RE-EVALUATION FORM

A. Re-evaluation Type: Design Change

Project Name: I-95(SR9) OVER MYRTLE AVE RAMP BR NO. 720163 FROM I-10 TO BEAVER ST

Project Location: FDOT District 2 (Duval County)

Figure 6 - I-95 Mainline Segment A

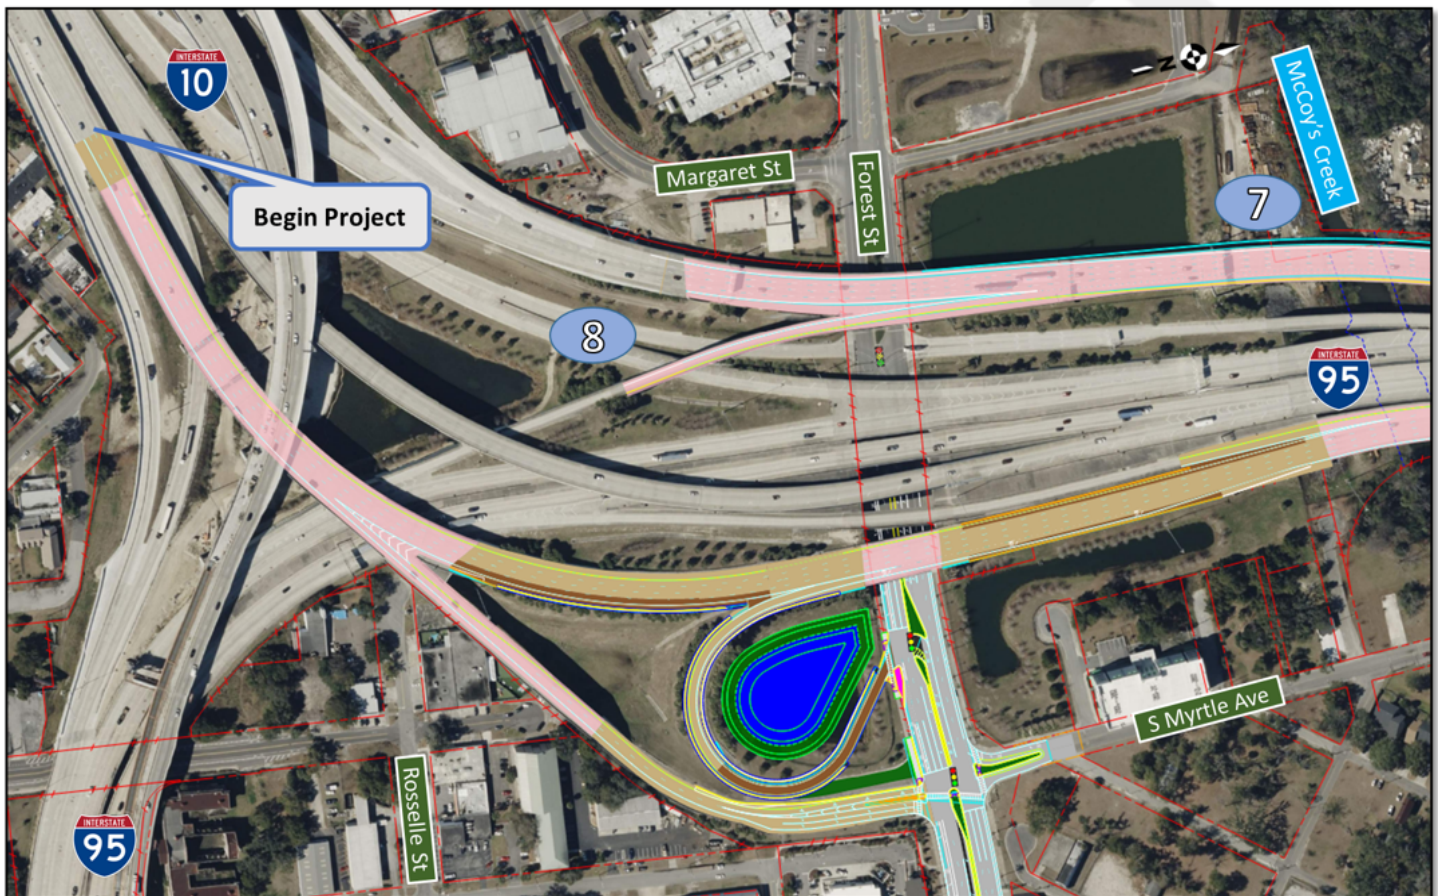
- The I-95 SB CD Road bridge over McCoy's Creek and Forest St. is no longer being widened, eliminating potential environmental impacts at McCoy's creek (revision 7).
- The I-95 SB CD Road off-ramp to I-95 SB will remain a single lane as it currently exists today (revision 8).

Figure 7 - I-95 Mainline Segment B

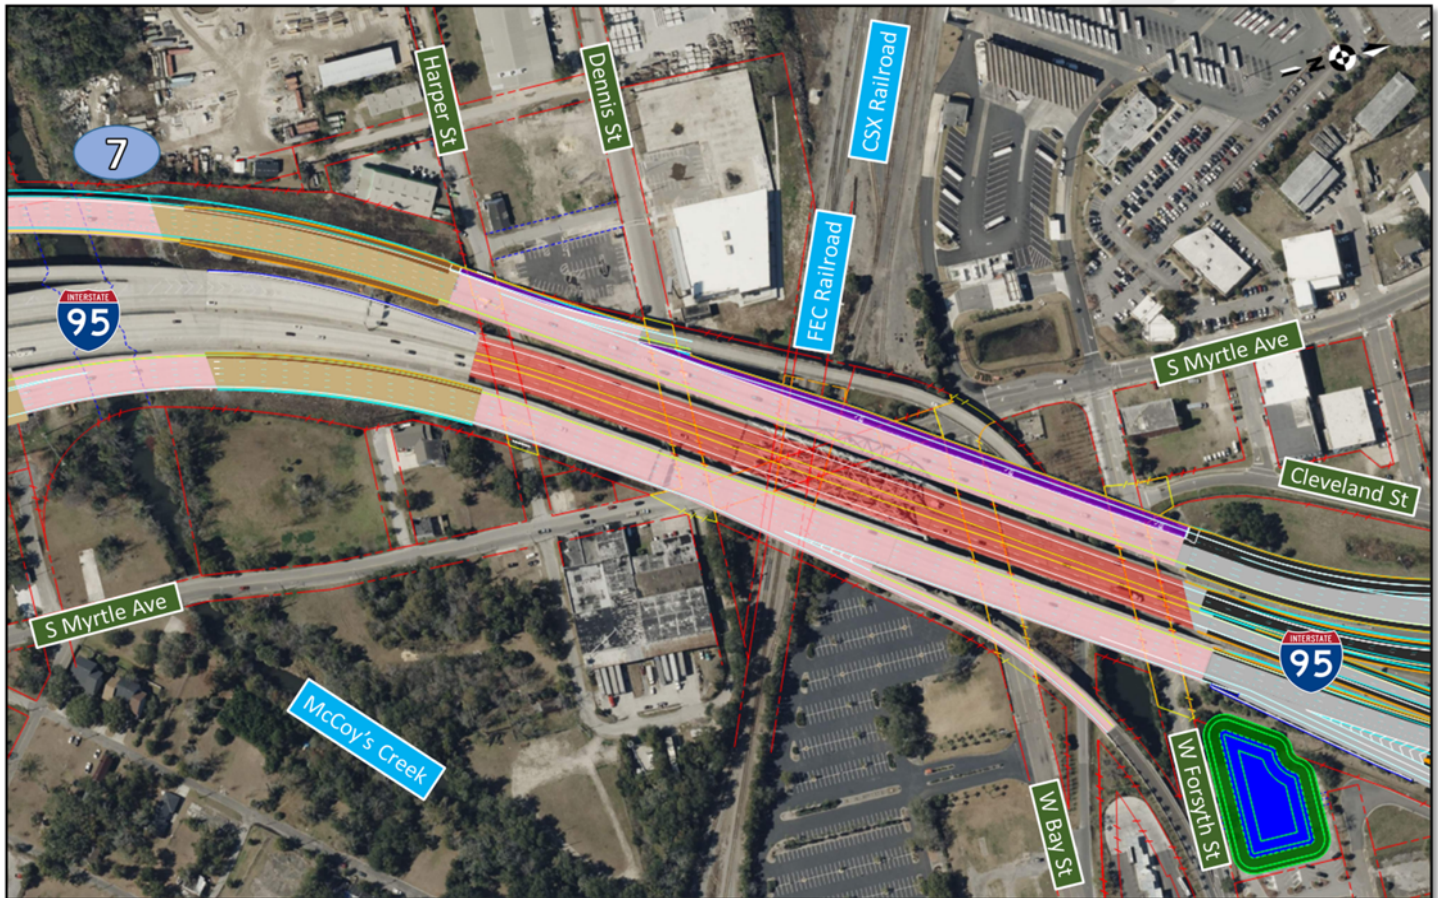
- The I-95 SB CD Road bridge over McCoy's Creek and Forest St. is no longer being widened, eliminating potential environmental impacts at McCoy's creek (revision 7).

Note: Revision 7 continues from Figure 6 with the elimination of the widening over McCoy's Creek.

Figure 8 - I-95 Mainline Segment C

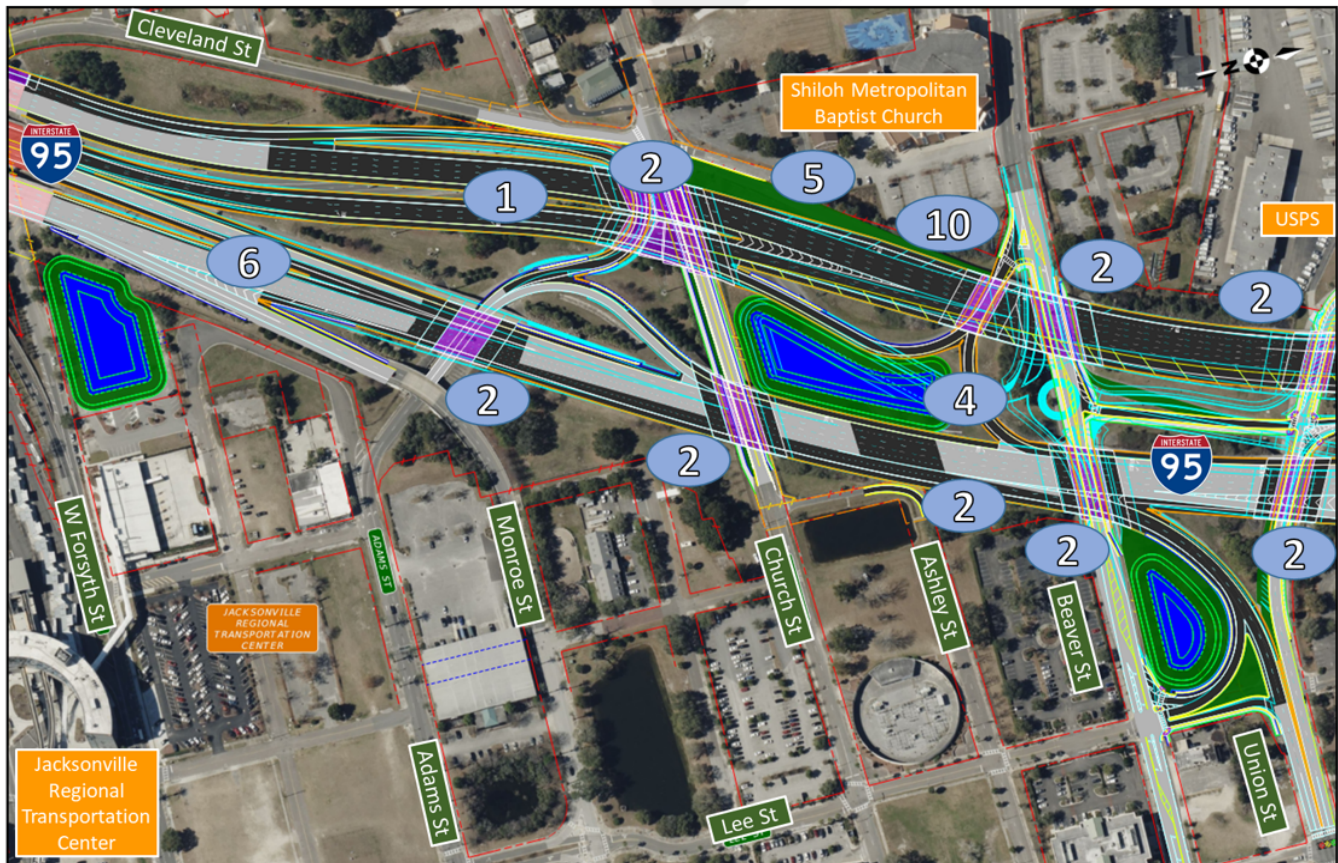
- North of Forsyth St., a section of I-95 SB is being realigned to remedy a high crash area related to substandard superelevation and stopping sight distance. Along with the I-95 SB realignment, the split between the I-95 SB CD Road and I-95 SB is being moved farther north to prevent "lane diving" from the Beaver St. on-ramp to I-95 SB (revision 1).

- Bridge replacements are being proposed for I-95 NB over Adams St., Church St., Beaver St., and Union St.; and I-95 SB over Church St., Beaver St. on-ramps to I-95, Beaver St., and Union St. due to age and deteriorating conditions. The existing bridge at I-95 NB over Ashley St. will be removed and replaced with earthen embankment. Furthermore, the structures that are being replaced will utilize innovative bridge designs to increase the existing substandard vertical clearances to at least 16' at all locations (revision 2).

- The proposed roundabout along Beaver St. has been removed, along with the access ramp from the roundabout to I-95 NB and the bridge that spanned Union St. Additionally, the proposed roadway connecting the roundabout and Church St., including the intersection has been eliminated. Access to I-95 NB and I-95 SB will be provided from Adams St. and Beaver St. as currently exists (revision 4).

- I-95 SB off-ramp to Church St. is being eliminated. The Preferred Alternative provided access from I-95 SB via the Union St. off-ramp and the proposed roundabout; however, with the proposed revisions, no direct access will be provided to Church St. and traffic will utilize the adjacent existing roadway network (revision 5).

- The gore area between I-95 NB and the I-95 NB CD Road is being shortened to provide a greater distance for lane changes from I-95 NB to Union St. and Beaver St. (revision 6).

- A dedicated left turn from Beaver St. westbound to I-95 is being added (revision 10).

Figure 9 - I-95 Mainline Segment D

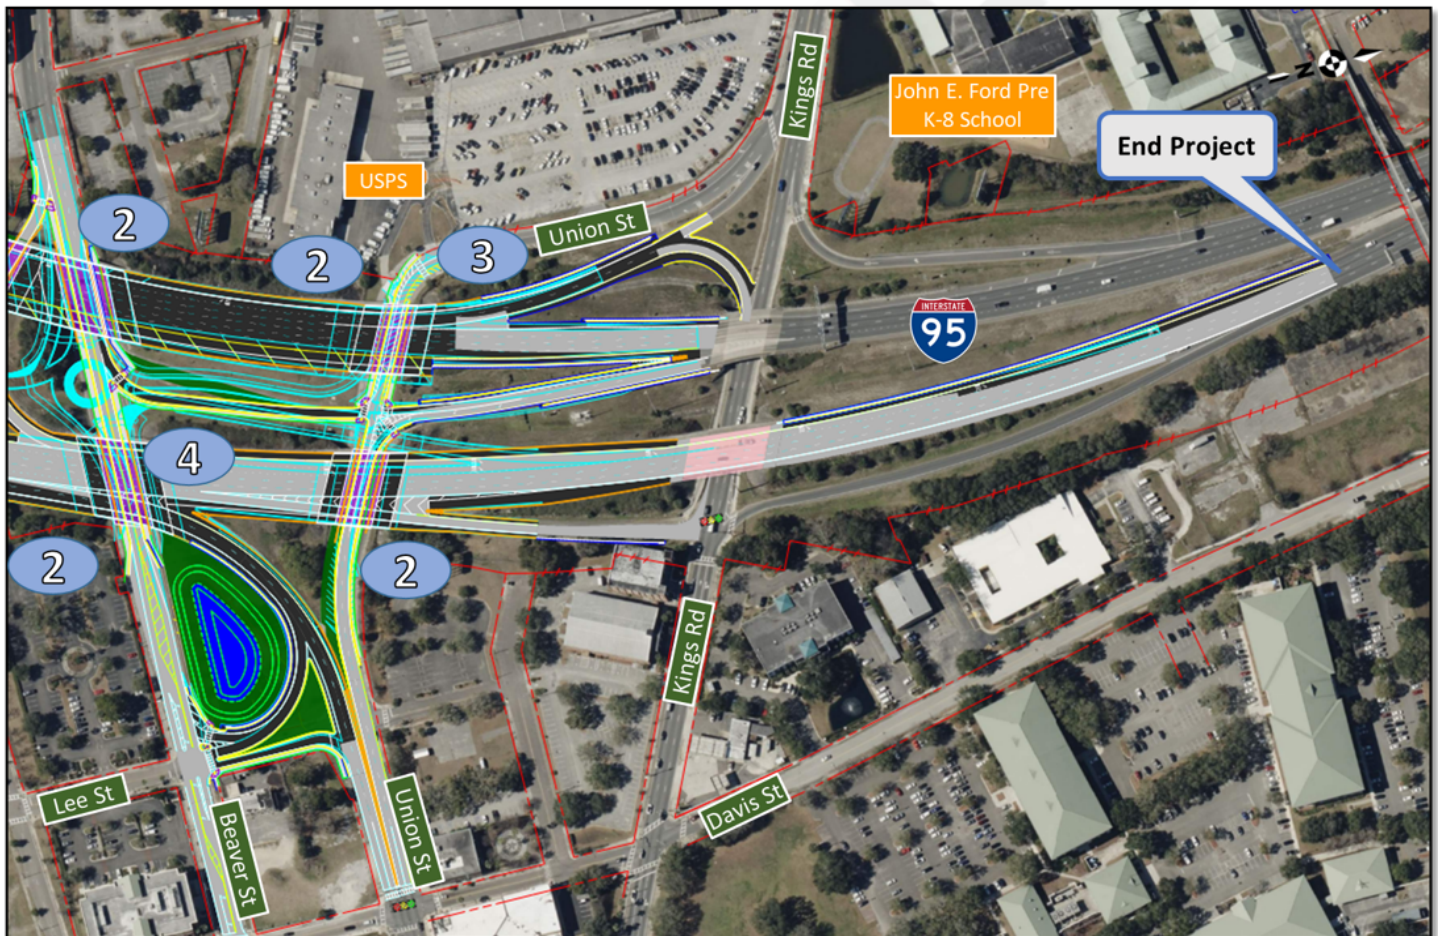
- Bridge replacements are being proposed for I-95 NB over Adams St., Church St., Beaver St., and Union St.; and I-95 SB over Church St., Beaver St. on-ramps to I-95, Beaver St., and Union St. due to age and deteriorating conditions. The existing bridge at I-95 NB over Ashley St. will be removed and replaced with earthen embankment. Furthermore, the structures that are being replaced will utilize innovative bridge designs to increase the existing substandard vertical clearances to at least 16' at all locations (revision 2).

- The on-ramp from Kings Rd. to I-95 SB is being widened to 2-lanes (revision 3).
- The proposed roundabout along Beaver St. has been removed, along with the access ramp from the roundabout to I-95 NB and the bridge that spanned Union St. Additionally, the proposed roadway connecting the roundabout and Church St., including the intersection has been eliminated. Access to I-95 NB and I-95 SB will be provided from Adams St. and Beaver St. as currently exists (revision 4).

- A dedicated left turn from Beaver St. westbound to I-95 is being added (revision 10).

Figure 10 - Park Street & Forest Street Area

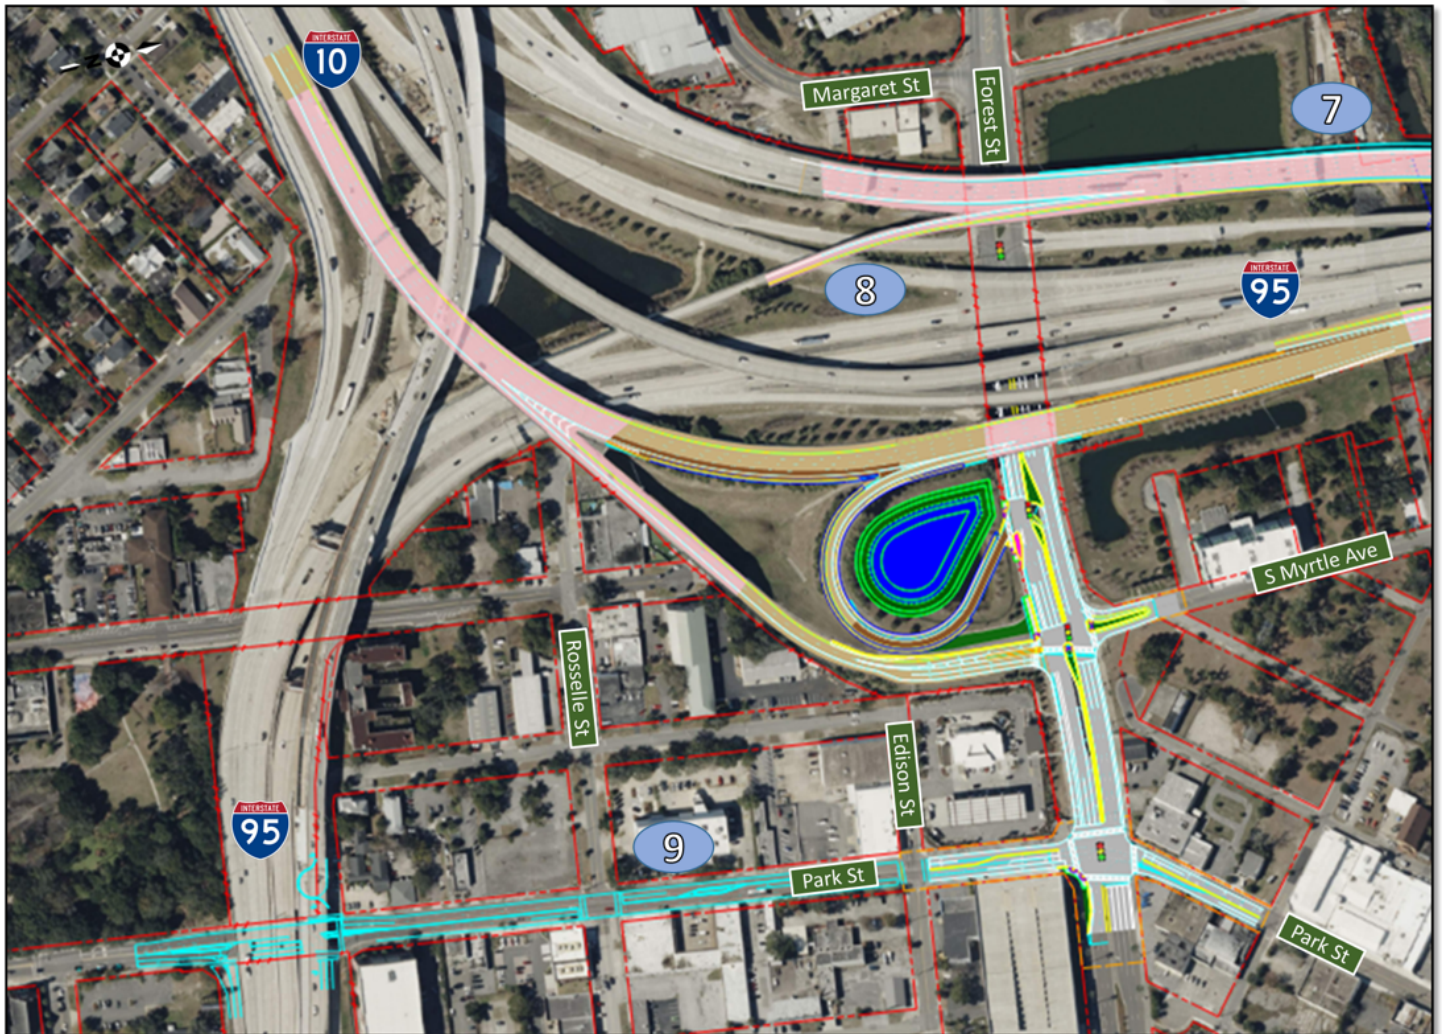
- The I-95 SB CD Road bridge over McCoy's Creek and Forest St. is no longer being widened, eliminating potential environmental impacts at the creek (revision 7).
- The I-95 SB CD Road off-ramp to I-95 SB will remain a single lane as it currently exists today (revision 8).
- Park St. roadway improvements and access changes between I-95 and Edison St. have been eliminated from the project (revision 9).
